UNITED STATES PATENT AND TRADEMARK OFFICE

APPLICATION NO.	FILING DATE	FIRST NAMED INVENTOR	ATTORNEY DOCKET NO.	CONFIRMATION NO.
10/734,040	12/10/2003	Douglas R. Dole	26978 USA	9198
23307	7590	06/09/2006	EXAMINER	
SYNNESTVEDT & LECHNER, LLP 2600 ARAMARK TOWER 1101 MARKET STREET PHILADELPHIA, PA 191072950			DUNWOODY, AARON M	
			ART UNIT	PAPER NUMBER
			3679

Office Action Summary

DETAILED ACTION

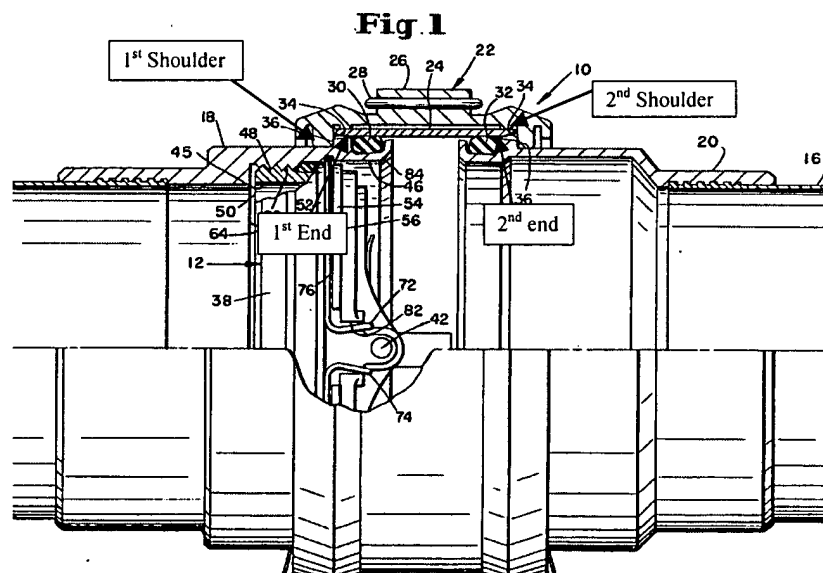
Claims 1-3, and 7-12 are rejected under 35 U.S.C. 102(b) as being anticipated by US patent 4621840, Foster.

In regards to claim 1, in Figure 1 below, Foster discloses a coupling assembly for flexibly joining pipes (14, 16) to one another end to end and permitting relative axial, torsional and angular deflection between the pipes, the coupling assembly comprising:

a first ring (18) attachable to an end of one of the pipes, the first ring having an outer diameter greater than the pipe and an outwardly facing circumferential groove therein;

a first sealing member (30) positionable within the groove of the first ring and extending circumferentially therearound;

a second ring (20) attachable to an end of another of the pipes, the second ring having an outer diameter greater than the other pipe and an outwardly facing circumferential groove therein;

a second sealing member (32) positionable within the groove of the second ring and extending circumferentially therearound;

a band (24) positionable in overlying relation with and surrounding the first and second rings, the band having an inwardly facing surface sealingly engageable with the first and second sealing members and having a width sufficient to allow a gap between the pipes; and

a housing (22) positionable in overlying relation with and surrounding the rings and radially spaced apart from the band, the housing having a pair of first shoulders positioned in spaced apart relation, each the first shoulders being engageable with one of the rings for limiting axial and angular deflection of one pipe relative to the other, and a pair of second shoulders each said shoulder being positioned on an opposite side of the band, each shoulder being engageable with an edge of the band for maintaining the band engaged with the sealing members.

In regards to claim 10, in Figure 1 above, Foster discloses a coupling flexibly joining pipes to one another end to end and permitting axial, torsional and angular deflection between the pipes, the coupling comprising:

Applicant argues that Foster does not disclose a pair of second shoulders each said shoulder being positioned on an opposite side of the band. The Examiner disagrees. In Figure 1 above, Foster clearly illustrates a pair of second shoulders each said shoulder being positioned on an opposite side of the band, meeting the claim limitation.

**FIG. 4A**

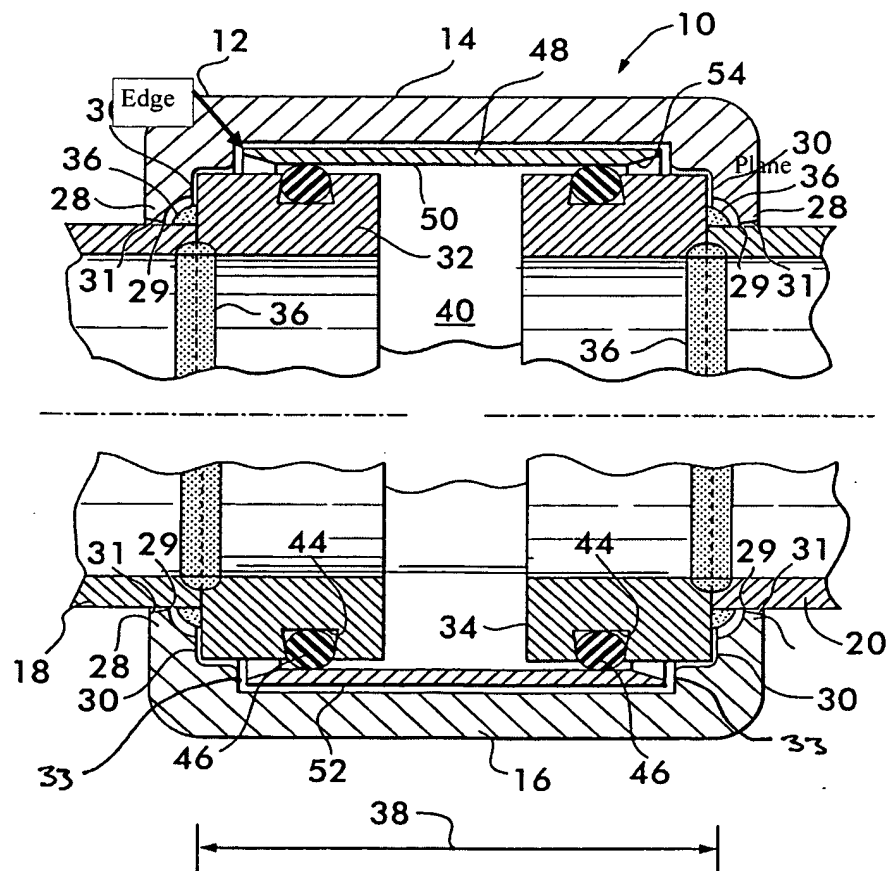
Applicant argues that Foster does not disclose each shoulder being engageable with an edge of the band. The Examiner disagrees. Applicant's Figure 1 discloses each shoulder being engageable with a plane of the band and not an edge (see Figure 4A of instant application).

An edge is:

3 : a line or line segment that is the intersection of two plane faces (as of a pyramid) or of two planes. [*Merriam-Webster Online Dictionary copyright © 2005 by Merriam-Webster, Incorporated*]

Therefore, Foster discloses each shoulder being engageable with an edge of the band in the same manner that the applicant's "edge" or plane is engagable with each shoulder.
